Service Bulletin

NO. 338

Studebaker and
Packard

FRONT SEAT CUSHION SPRING MODIFICATION AND RELOCATION OF COVER TO ELIMINATE CUSHION COVER DAMAGE - 1958 2-DOOR MODELS

Fig. 1

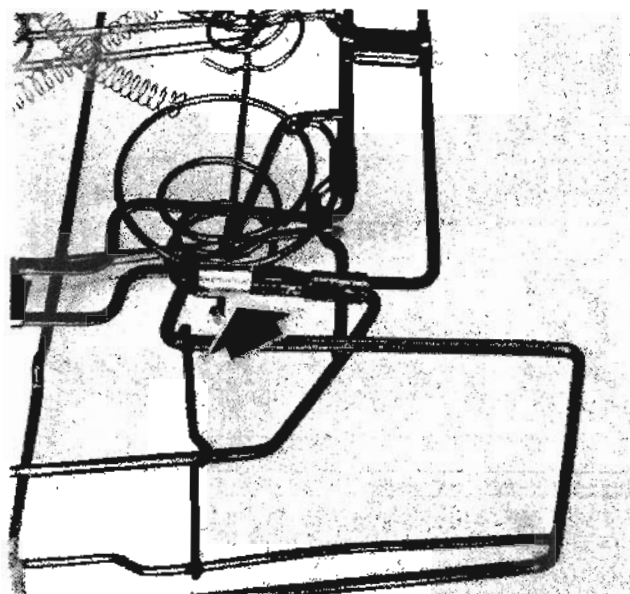
The installation of a second clip (see Fig. 1) on each side of the cushion spring assembly and relocation of the cushion padding as shown in Fig. 2 will eliminate the possibility of cushion cover damage in the clip area. This change entered production with the following serial numbers:

When the clip loosens, the spring assembly top rim and skirt wires separate and cause additional pressure on the cushion cover which may result in damage. Should evidence of this condition appear, on the vehicles manufactured prior to the above serial numbers, immediate action should be taken to fabricate and install a second clip and relocate the padding as described.

The clip may be made from a piece of stock .045" - .050" thick, 5/8" wide and 1 1/2" long.

Place the flat side of the top rim wire directly on top of the skirt wire as shown on Fig. 1 then install the fabricated clip securely.

FIG. 3

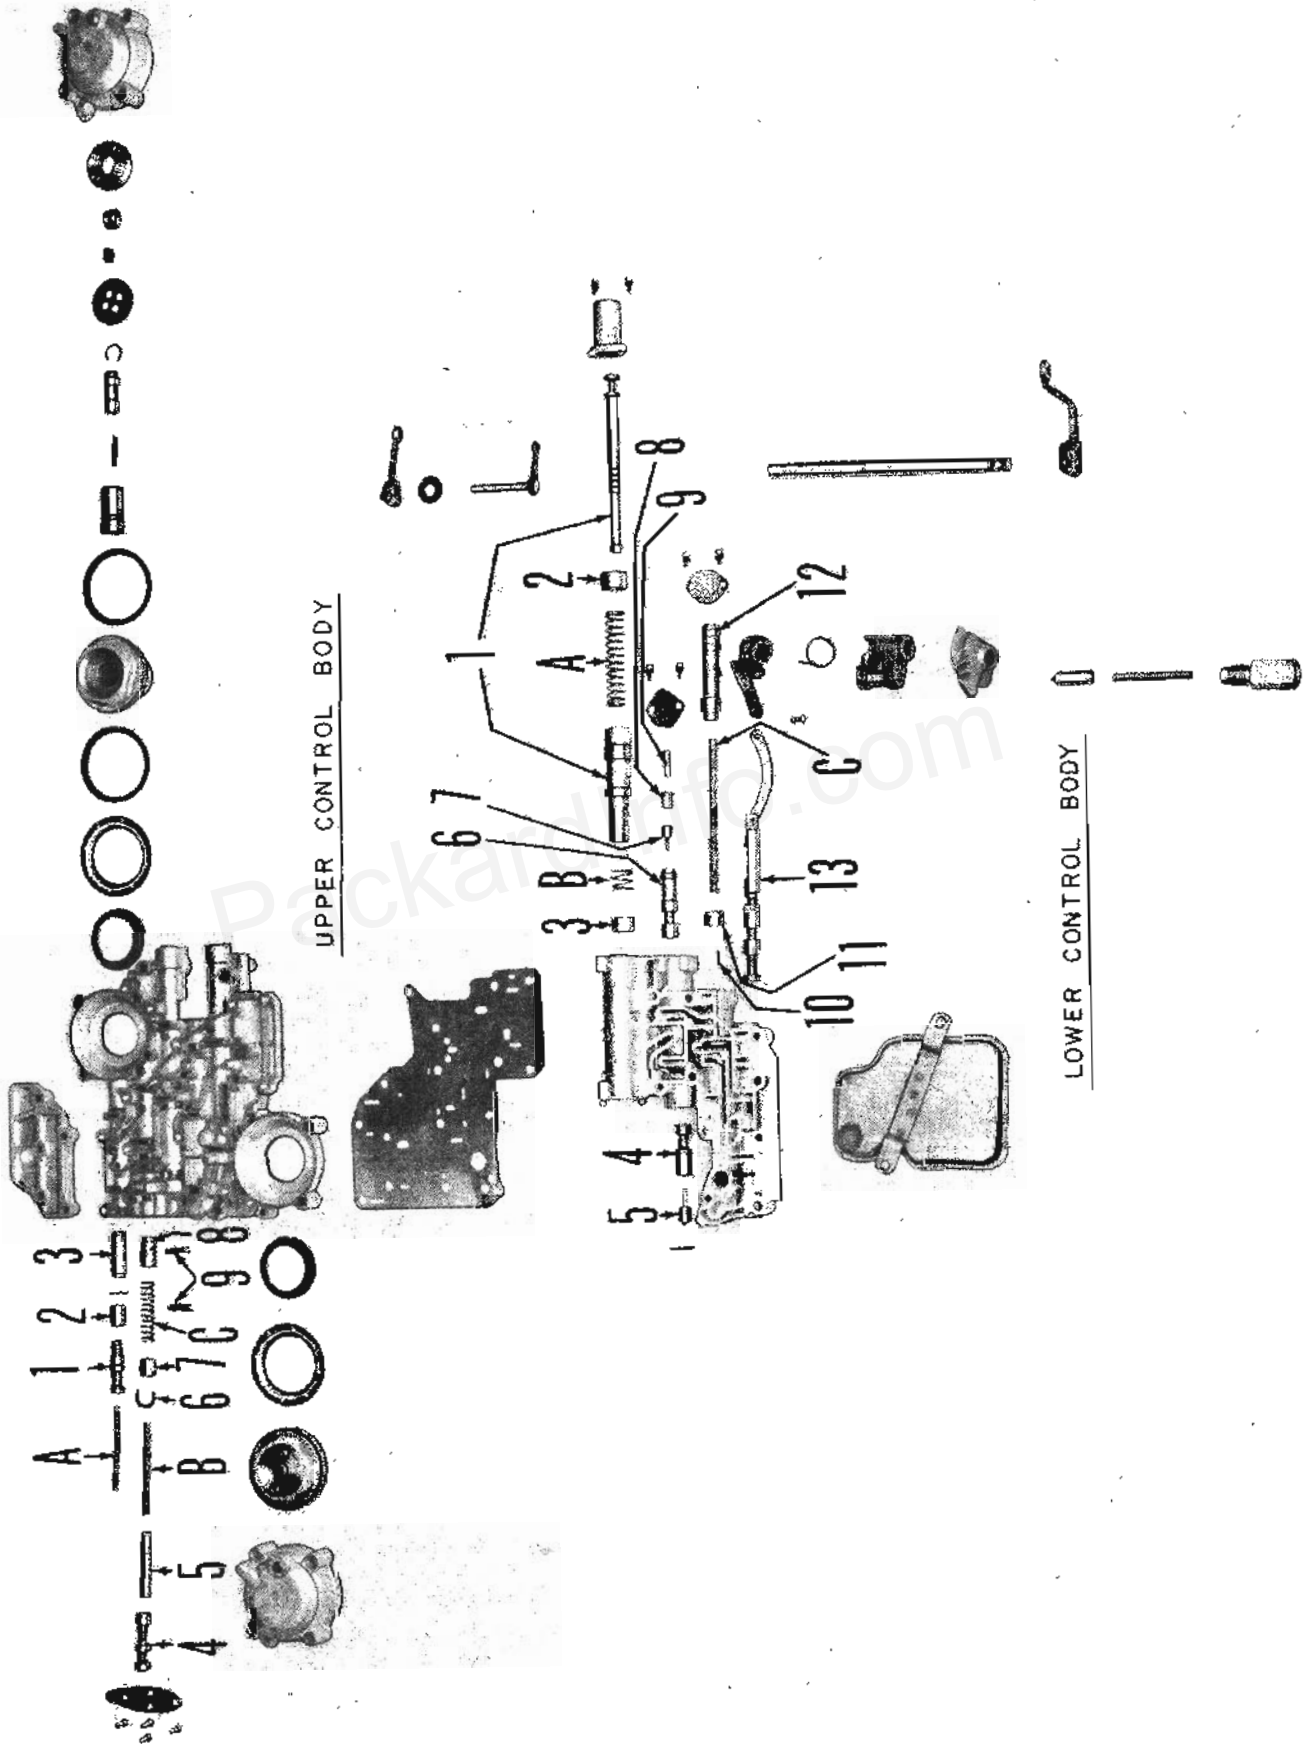
The Valve Control Assembly illustrated in Fig. 3 is Part No. 423800 and is the standard control unit as used in the 1954 Ultramatic prior to gear start. It is supplied for service as a complete assembly replacement for all Ultramatic Transmissions of the 23rd Series after transmission No. 101509, Model 2301 and transmission No. 5360, Models 2302-06, and all 24th Series through the 54th.

Timing Valve, Part No. 434758 applies to Valve Body Assembly, Part No. 423800 shown in the illustration, Timing Valve, Part No. 421866 applies to the original valve bodies in the 24, 25 and 26th series. The same spring, Part No. 421992 and the seat, Part No. 423012 apply to all valve bodies of the 24, 25, 26 and 54th series prior to gear start.

The separator plate illustrated, Part No. 423097, applies to all valve body assemblies of the 24, 25, 26 and 54th series prior to gear start.
